2005 BUILDING ENERGY EFFICIENCY STANDARDS

NONRESIDENTIAL
ACM MANUAL

EXPRESS TERMS – 45 DAY LANGUAGE
JULY 2003

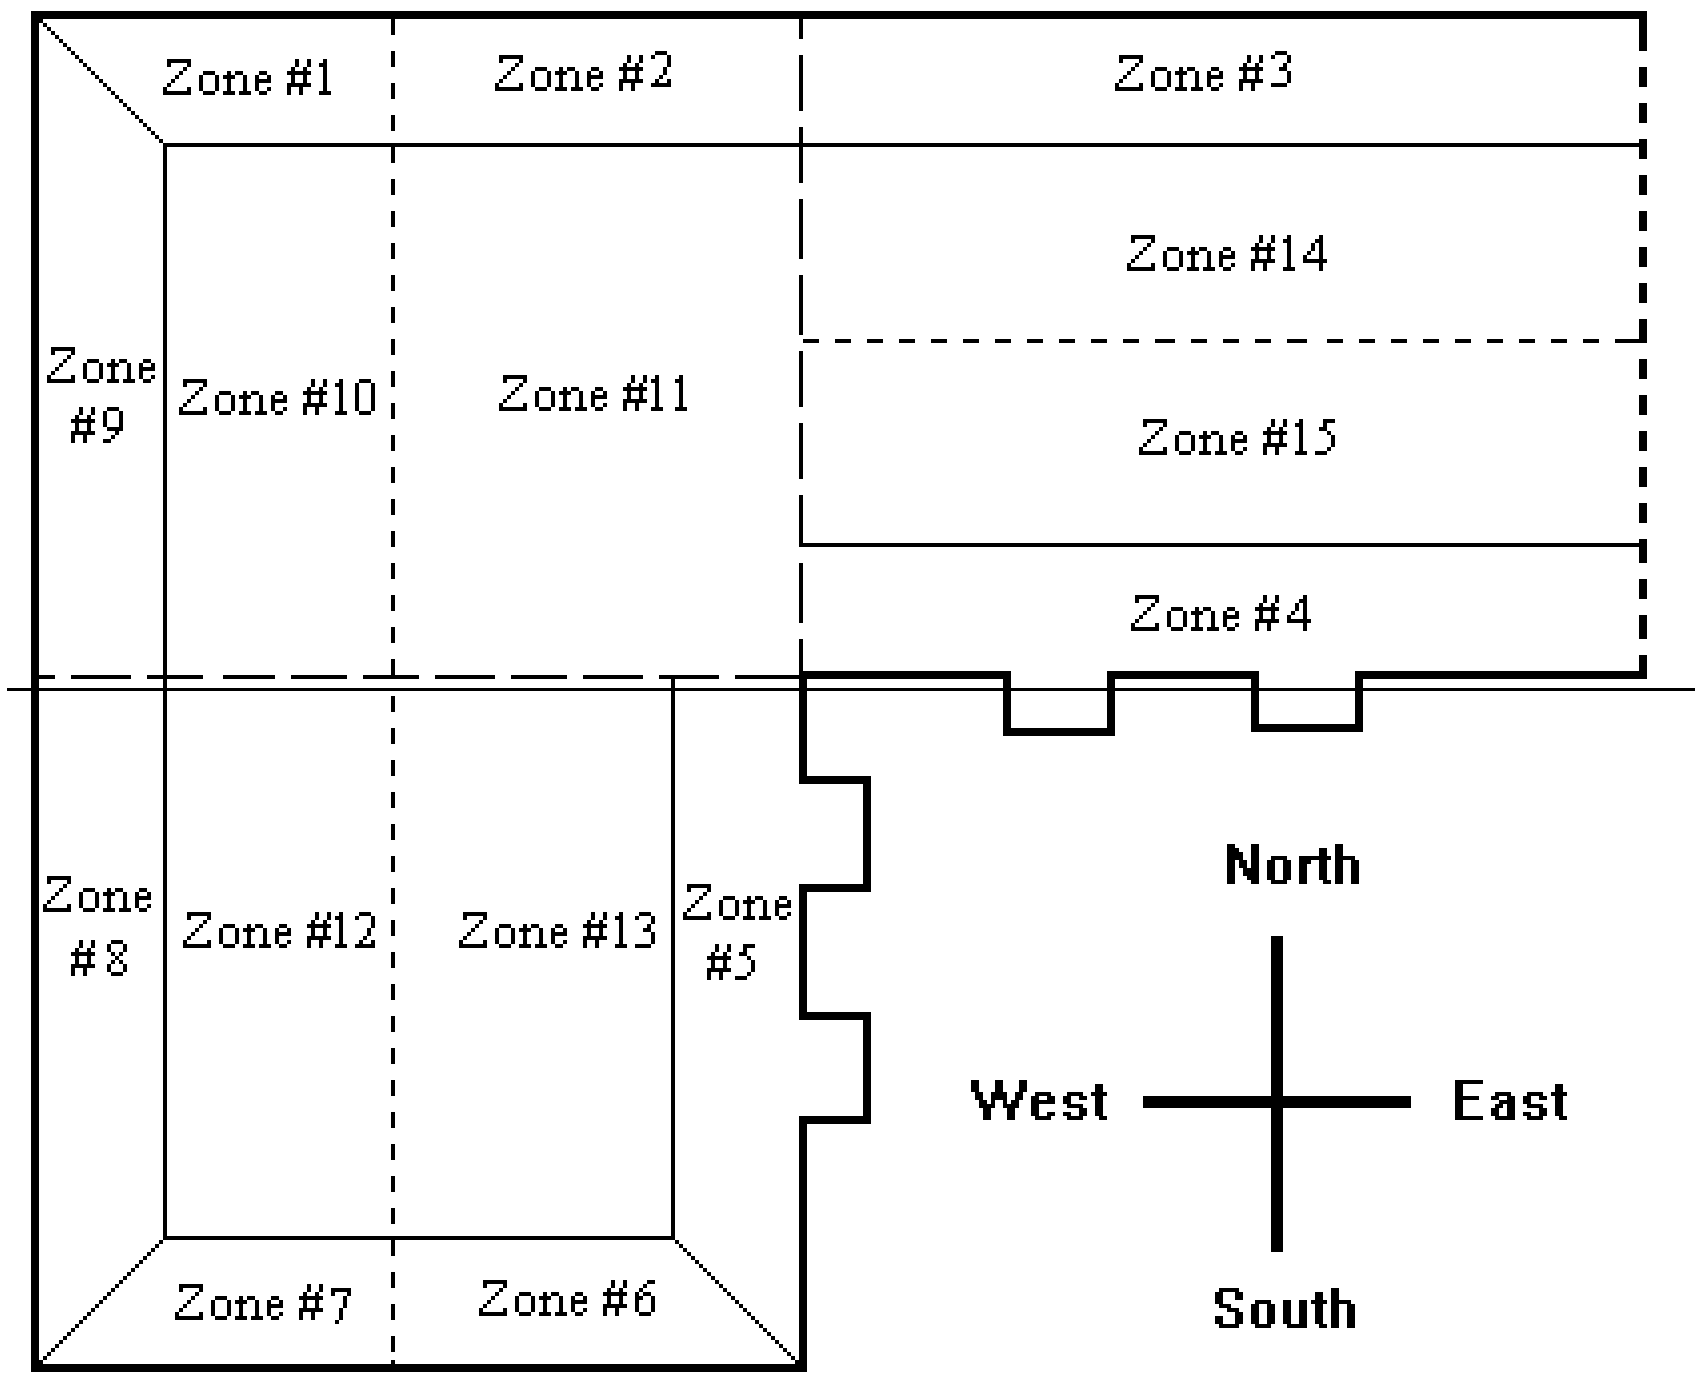
~~Example 3: This building is the same as the building in Example 1, except that the east facing wall is a demising wall.~~

Figure N5-3 – Prototype D

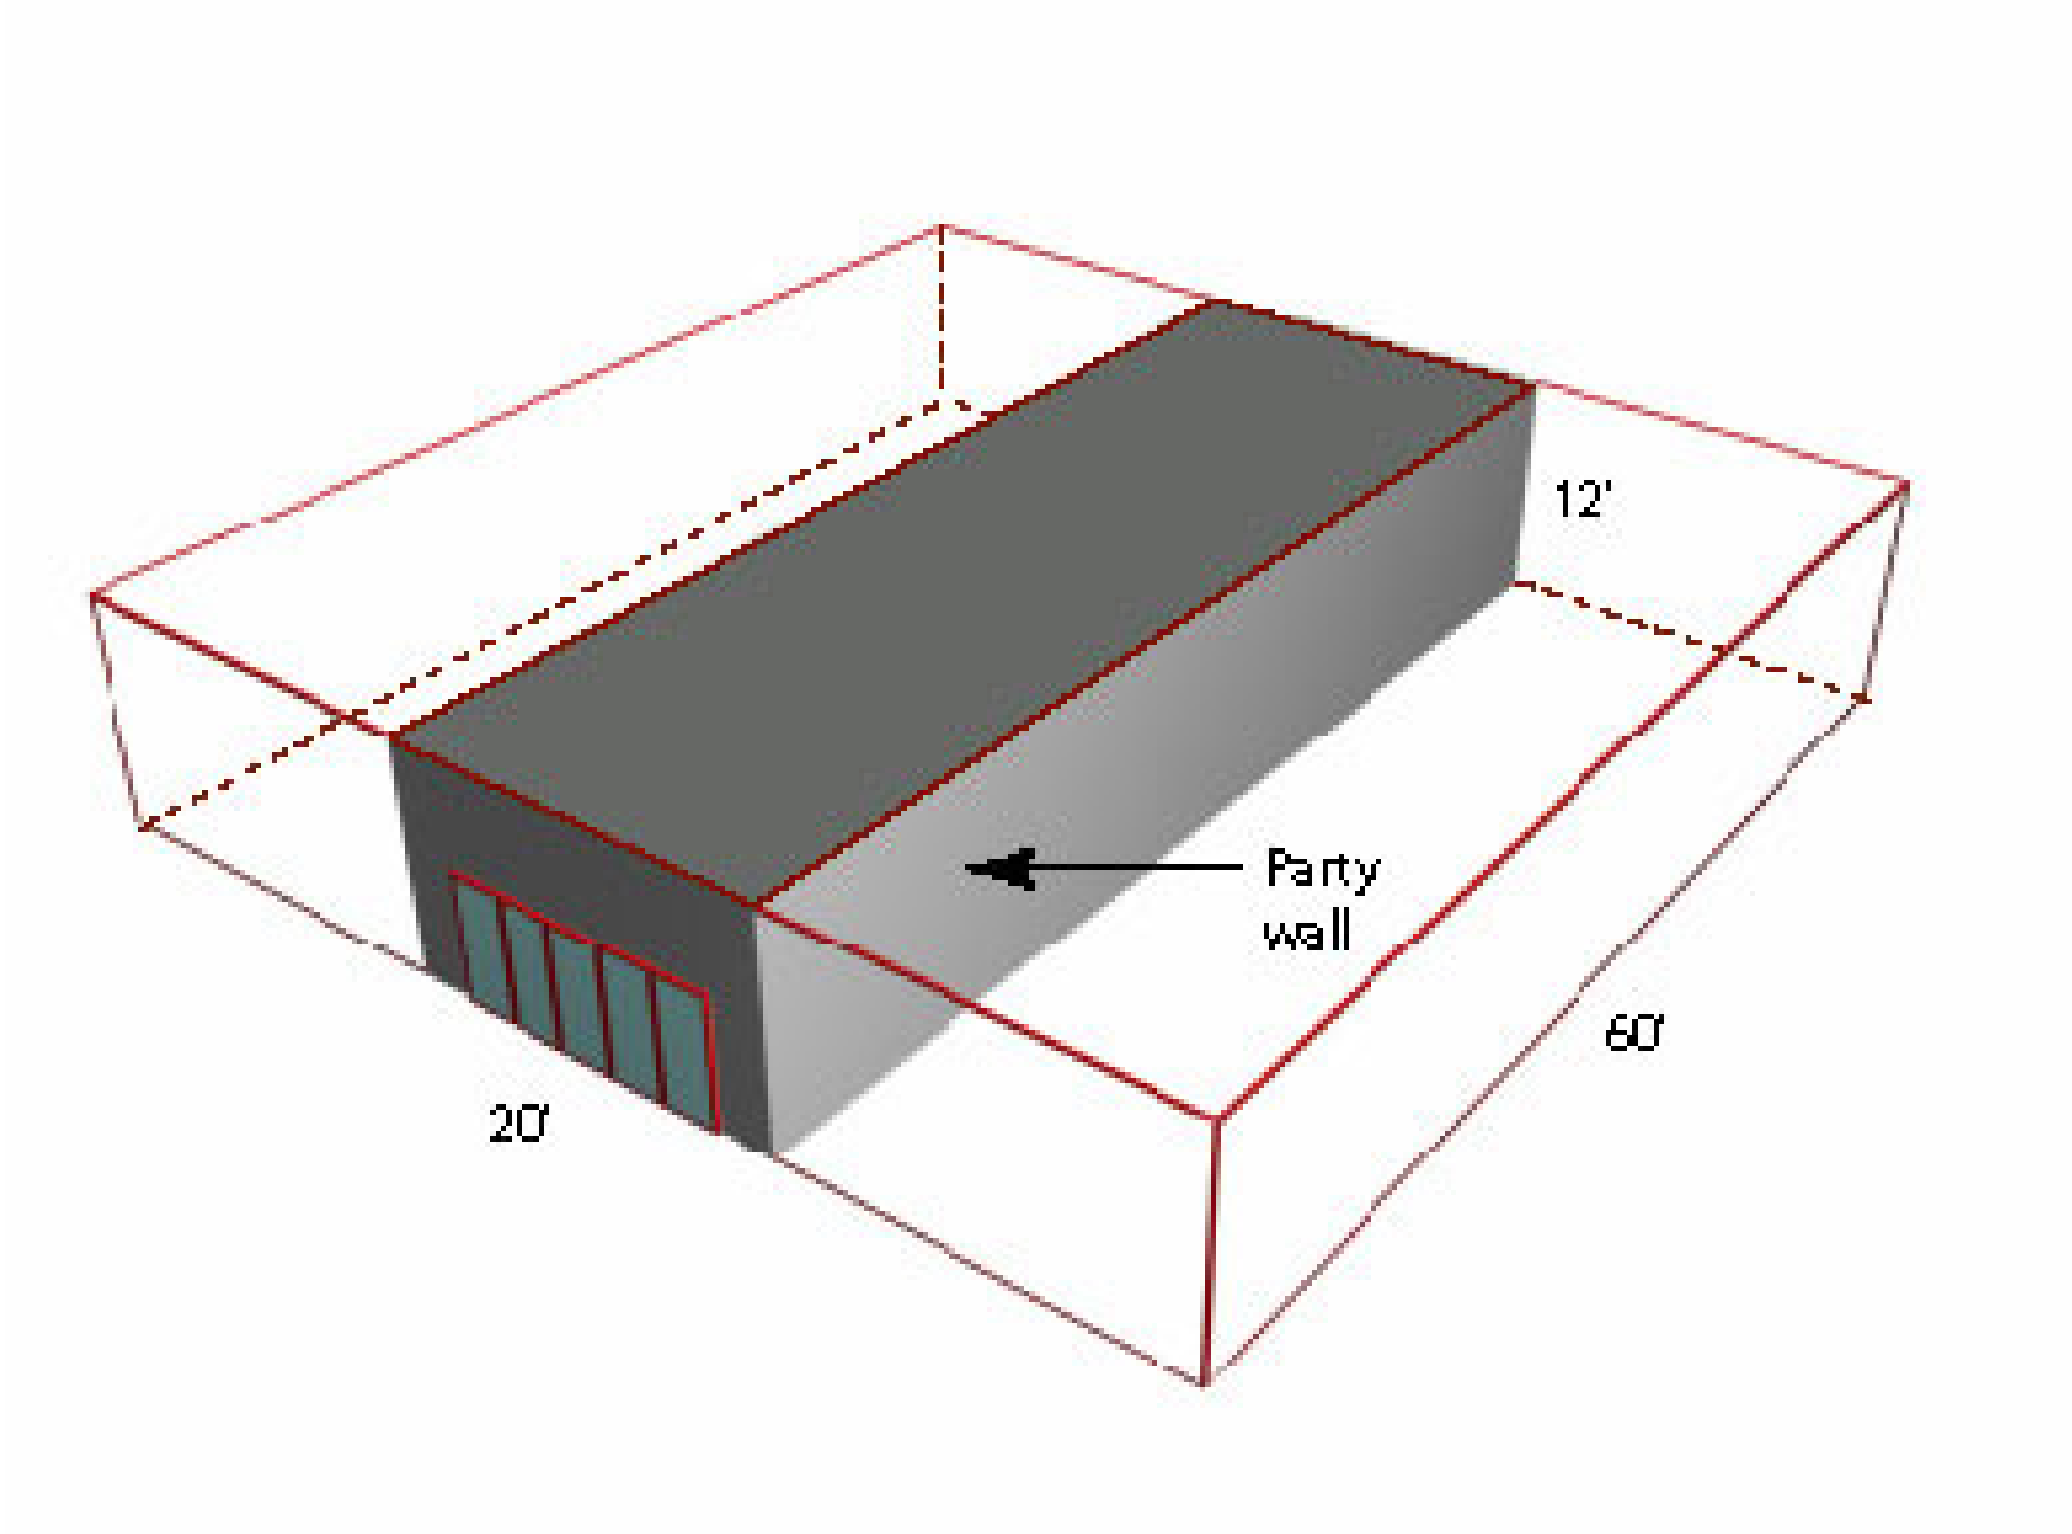
D) This prototype ~~is like~~ represents a tenant improvement space in that it has only two exterior walls with two demising "party" walls ~~with R-11 insulation between steel framing members~~. The "party" walls are each adjacent to an unconditioned space of the same dimensions as the conditioned space (viz. 20 ~~feet~~ft wide, 60 ~~feet~~ft deep and 12 ~~feet~~ft high). These party walls have nominal 2x4 steel stud framing with R-11 insulation between framing members and 0.5" sheetrock on either side [CONS = DEMISING]. The unconditioned space has three other exterior walls that use the IV11-A2 ~~W1A~~ wall-type construction. The roof/ceiling of the unconditioned spaces has R-11 insulation between 2x6 wood framing members [[IV3-A2]~~RF1B~~]. The D prototype building (both conditioned and unconditioned spaces) ~~is built~~ have a slab-on-grade floor. The unconditioned spaces are modeled using a slab without carpet or pad and with no slab edge insulation. For the conditioned space, the ~~nominally "west"~~ back wall is heavyweight concrete with no windows and a wood door and the ~~front "east"~~ front wall is a steel-framed wall with glazing. The space is 20 ~~feet~~ft wide and 60 ~~feet~~ft deep and has a height of 12 ~~feet~~ft. The glazing begins at ground level but varies in height from 4.8 to 6 ~~feet~~ft. Tests with this prototype use overhangs and skylights and rotate the whole building geometry.
